Friends of the North Coast
Rural Bonny Doon Association

April 18, 2024

Re: Comment Letter re Project for Northern Parking Area and Trailhead and Draft Environmental Assessment (DOI-BLM-CA-C090-2023-0001-EA) at Cotoni-Coast Dairies, a Unit of the California Coastal National Monument

Fig 2. Two-dimensional model for a 9.5-inch storm over a 24-hour period. EA page 23

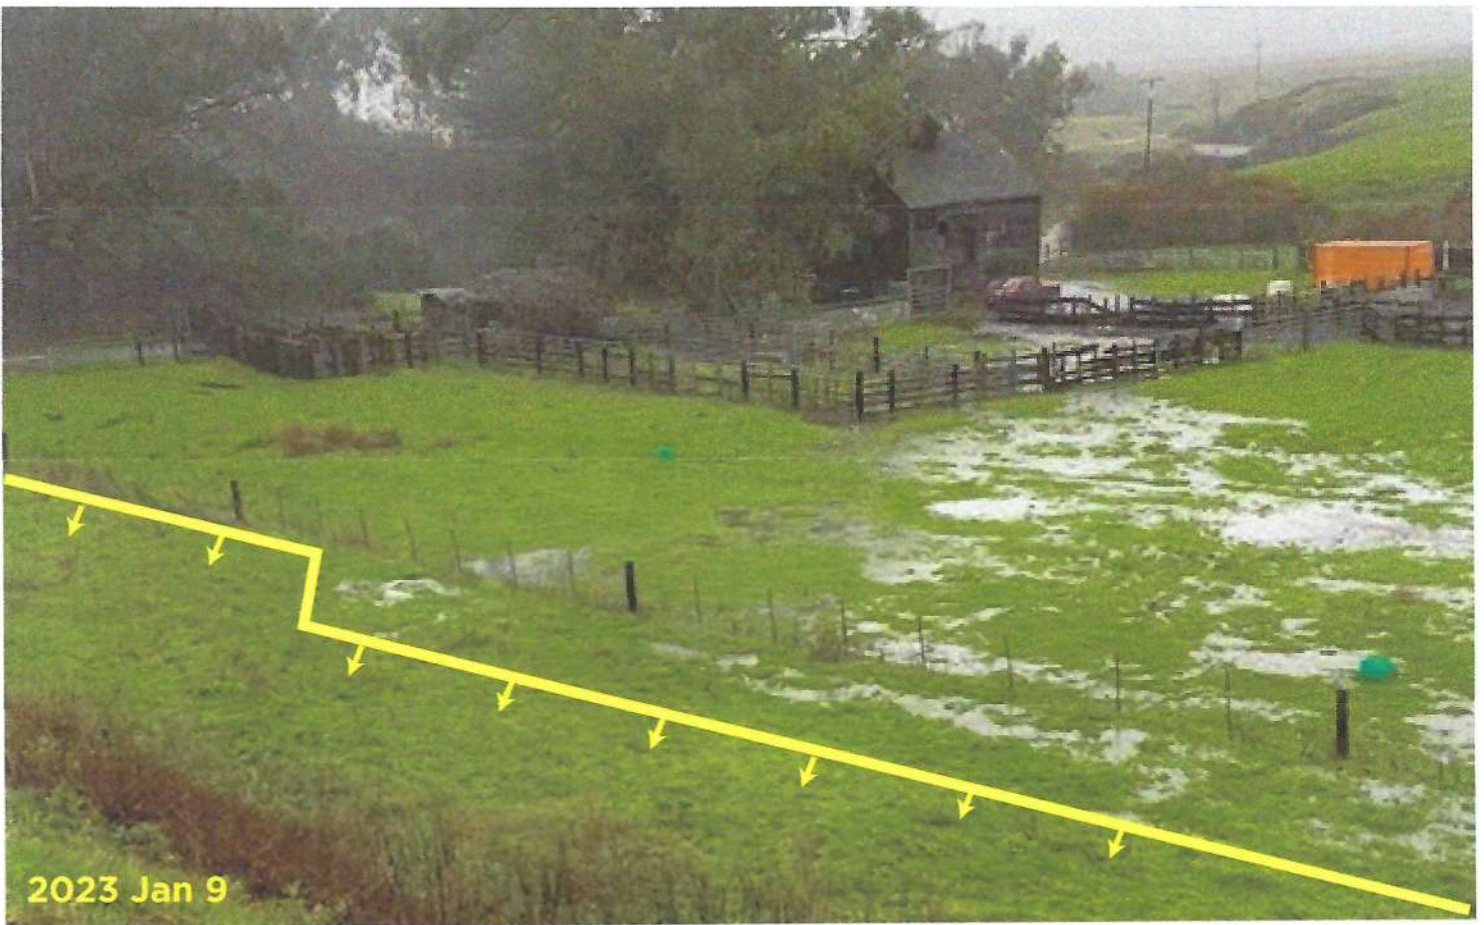
In BLM's "two-dimensional (2D) precipitation induced flooding model" shown on the right from EA p.23, BLM stated it used the nearest statistical records and a 9.5-inch storm over a 24-hour period.

BLM should inform the public as to the basis for using that storm and provide the name, credentials, and any underlying report identifying the "nearest statistical record" and reason for the model storm selected."

Roadway itself is proposed at a higher elevation.⁵ The EA has chosen a 9.5” in 24 hr. storm to show inundation of the corral area used by the cattle operation. The Community’s proposed Access Roadway location along the northern side of the base of the knoll is not inundated in the visual shown on EA page 23. The EA also shows photos of a 2024 inundation (following approximately 2.5 inches of rainfall over 24-hours from January 21 to January 22, 2024). The pasture proposed for the parking area was inundated and a large volume of surface water was observed flowing through the corrals onto Cement Plant Road and toward Agua Puerca Creek. However, the photo shows the Access Roadway location not inundated. Commenting Parties also provide photos of the January 8-9, 2023 storm inundation and next day dry-off which also shows the proposed Access Roadway location not inundated (next6 page).

During the 2023 storms that were a federally declared a disaster

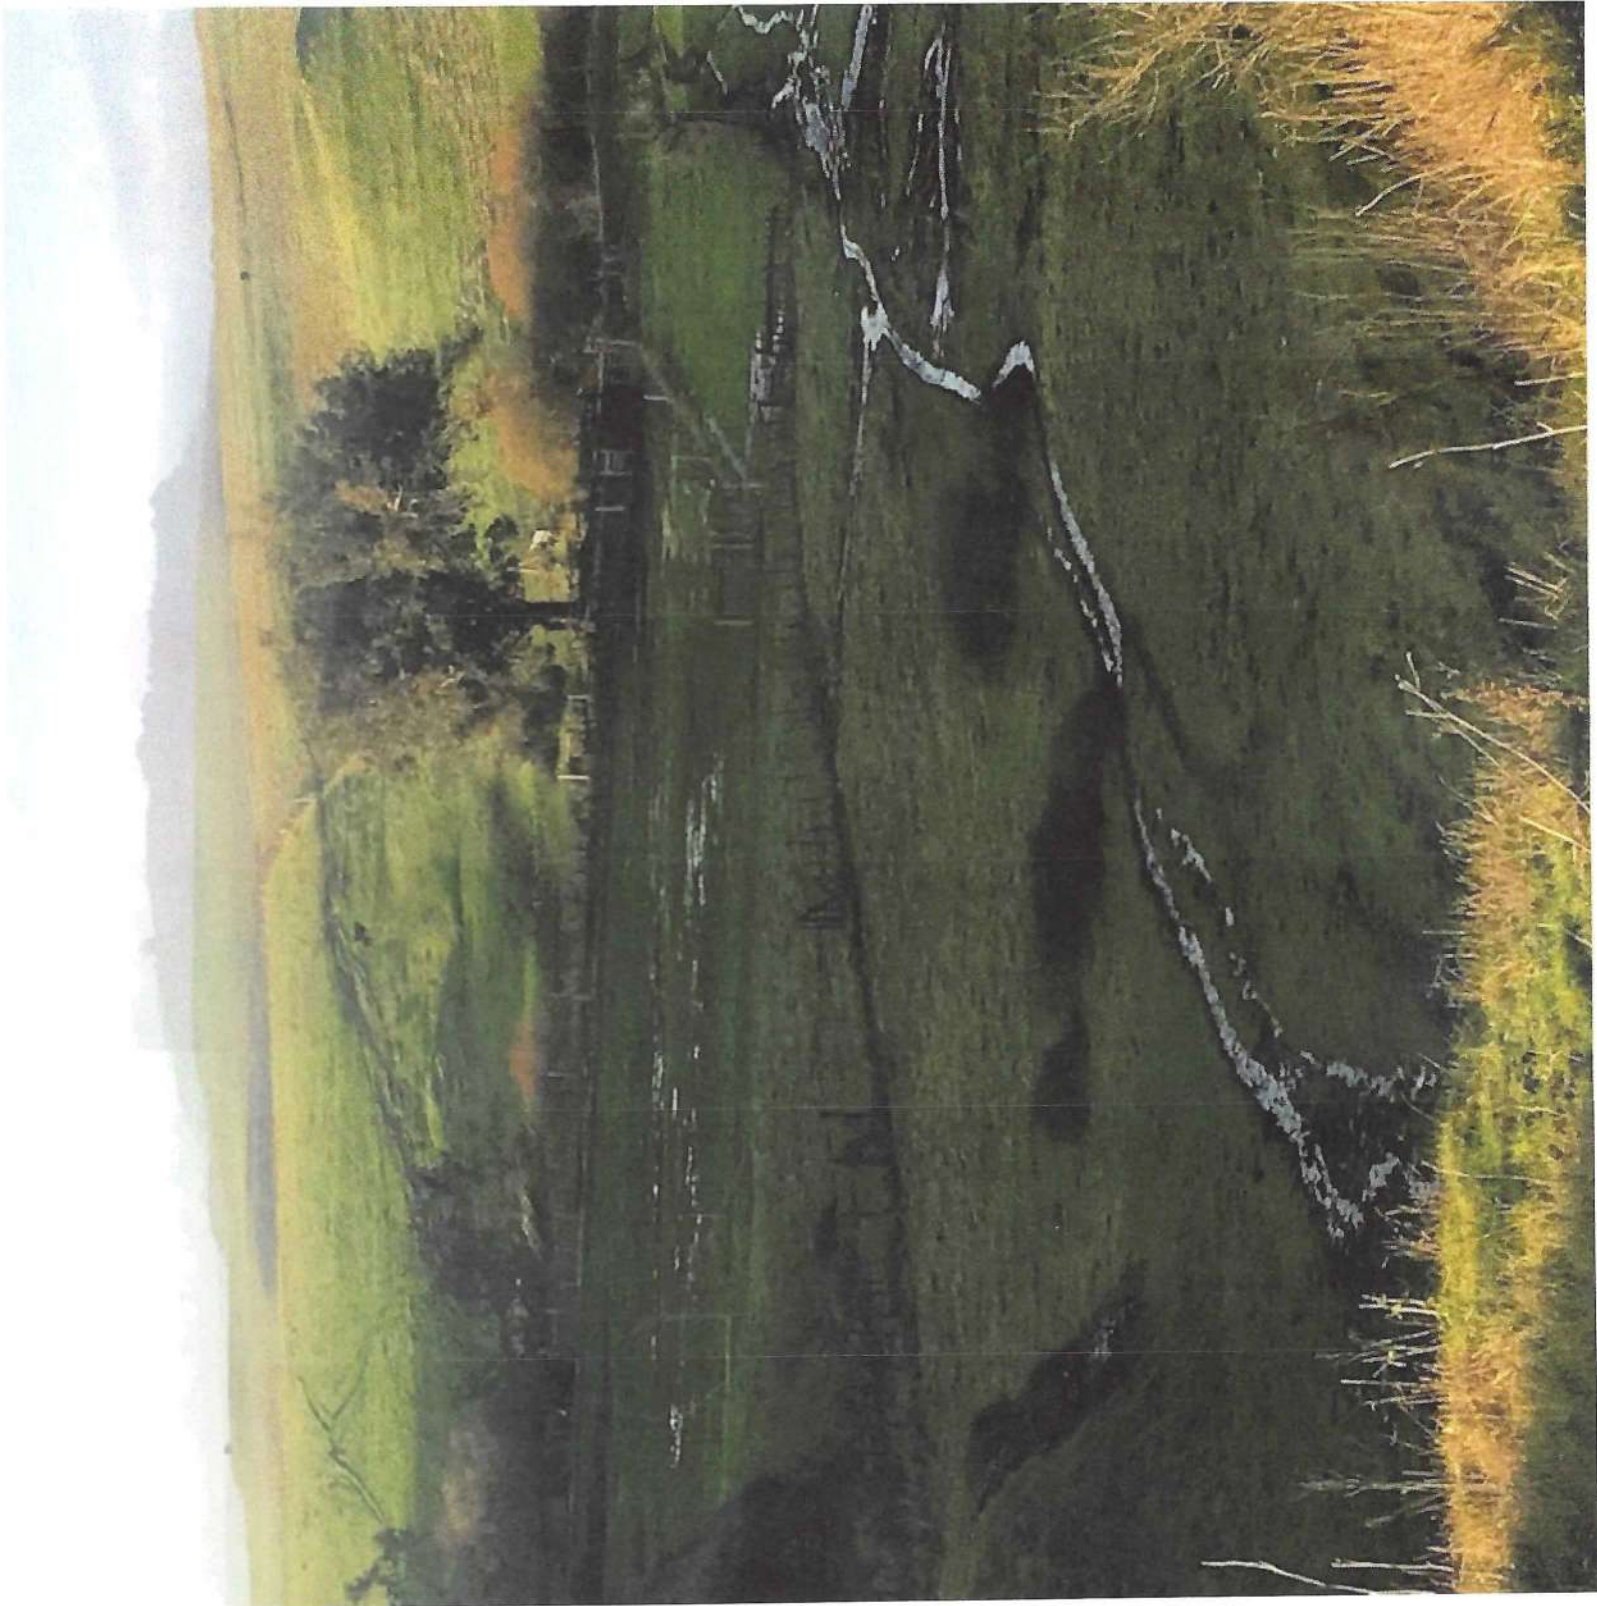
Furthermore, inundation during heavy precipitation events doesn't reach Access Roadway at base of knoll because the Access Road is at a higher elevation. By review of the Landscape Architect's professional drawing of the Community's lower level Access Road (at the time with parking along each side), because it is to scale, it demonstrates that there is room for the 24-foot wide Access Road outside of the inundated area. See EA page 24 along with the same photo and another marked to delineate non-inundated area (visuals attached after this page). The EA shows photos of a 2024 inundation (described as following approximately 2.5 inches of rainfall over 24-hours from January 21 to January 22, 2024). The pasture was inundated and a large volume of surface water was observed flowing through the corrals onto Cement Plant Road and toward Agua Puerca Creek. However, the photo shows the Access Roadway location not inundated. Commenting Parties also provide the following photos (copies attached after this page) of the January 8-9, 2023 storm inundation and next day dry-off which also shows the proposed Access Roadway location not inundated. In other words, the pasture and corral area drains rapidly. See comparison photo from January 10, 2023 following the large storm of the preceding days where the inundation of the day before has disappeared.

Within a 24-hour period, the water drained quickly:

Preferred Access for Knoll Parking

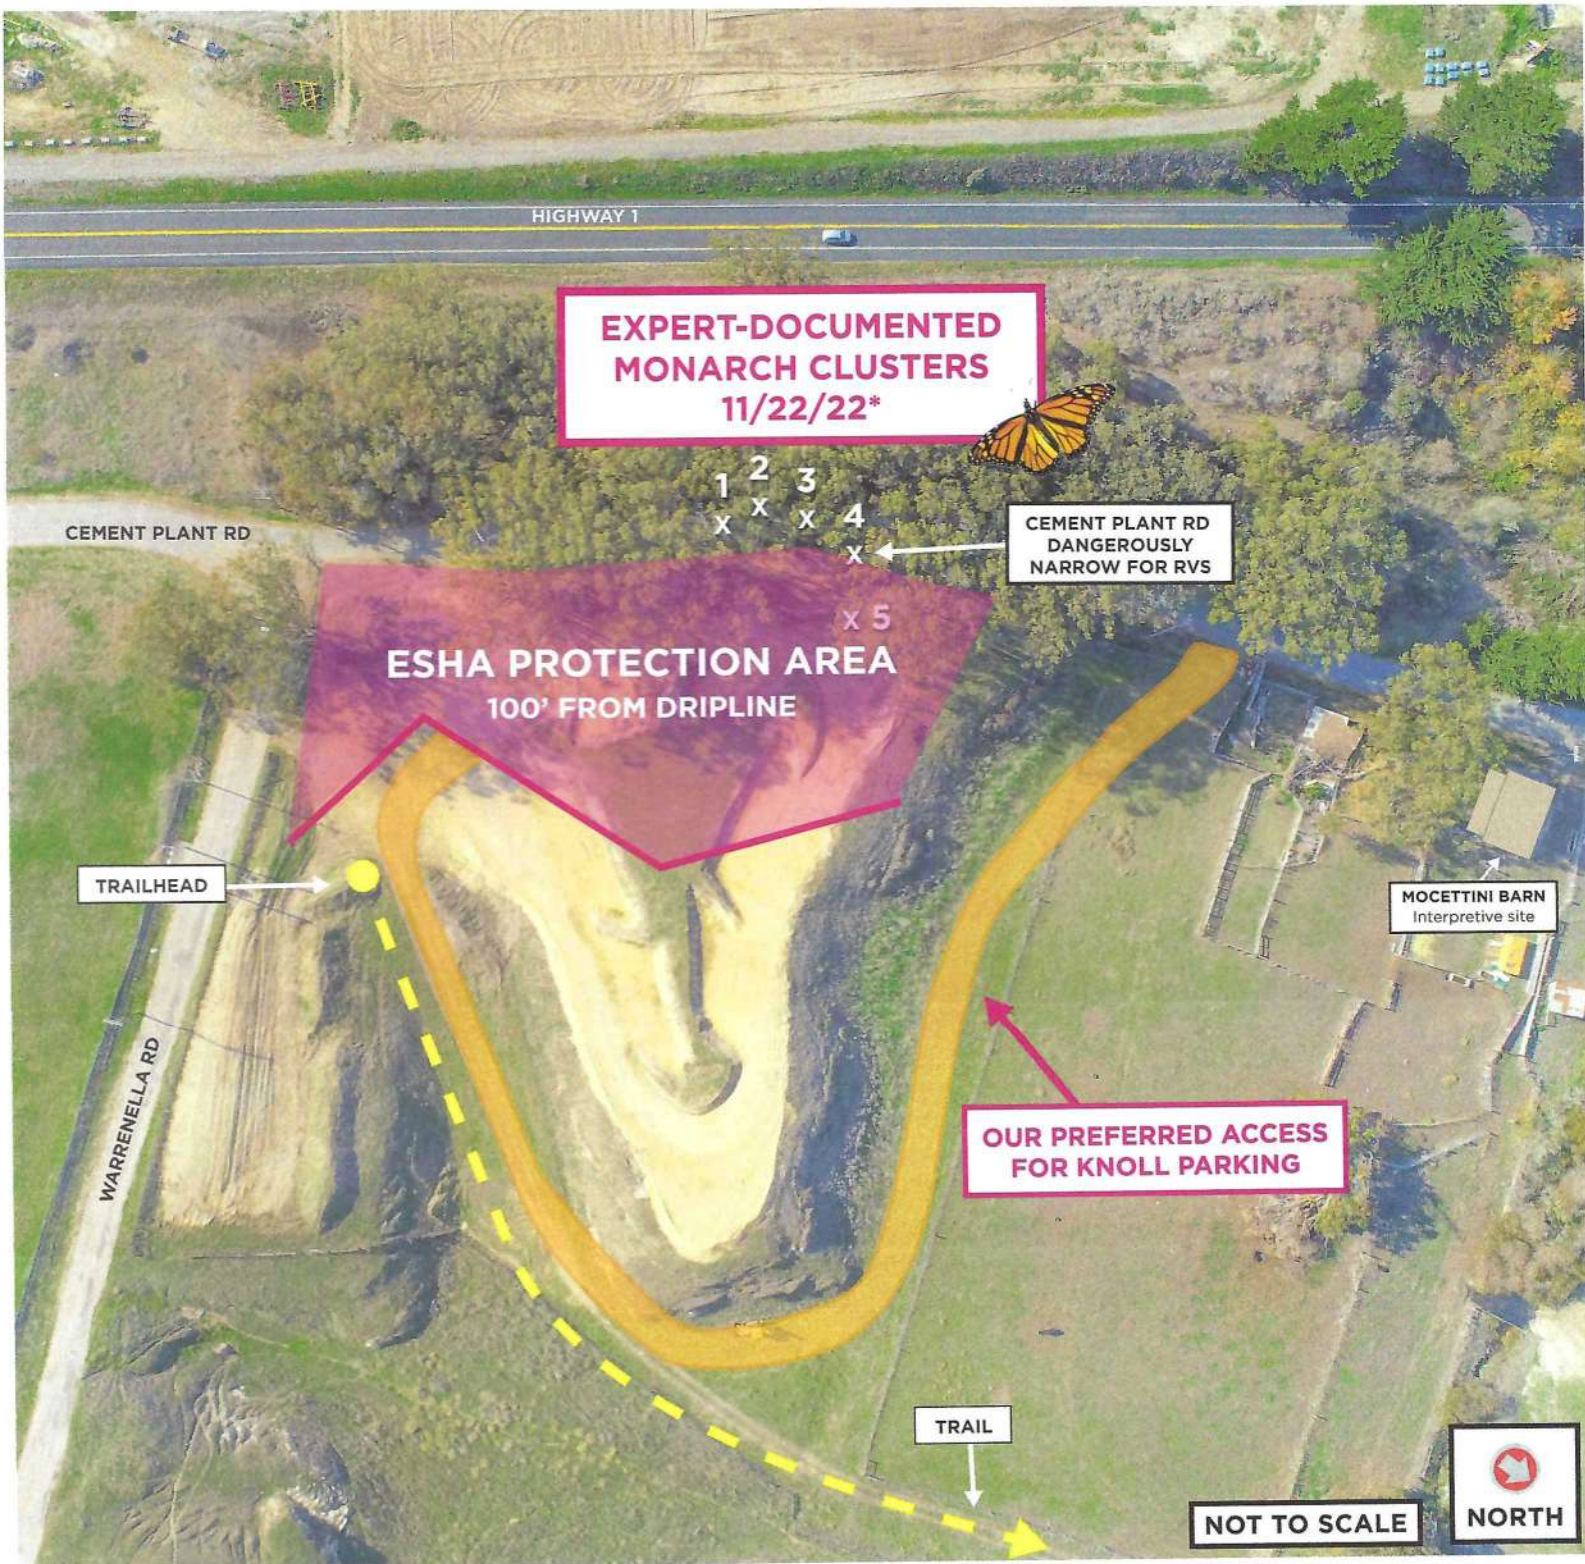
Commenting Parties continue to believe that an Access Road from Cement Plant Road along the base of the knoll, around its inland side, and up the draw to BLM’s proposed knoll-top Northern Parking Area is a viable and superior Alternative. A visual of this “Preferred Access for Knoll Parking” is on the next page. *This is preferable even if no parking is included at the Barn Site level.* We respectfully request BLM to consider that Alternative in either of the two following configurations, in order of our preference:

Avoids Monarch Habitat and Narrow Stretch on Cement Plant Road
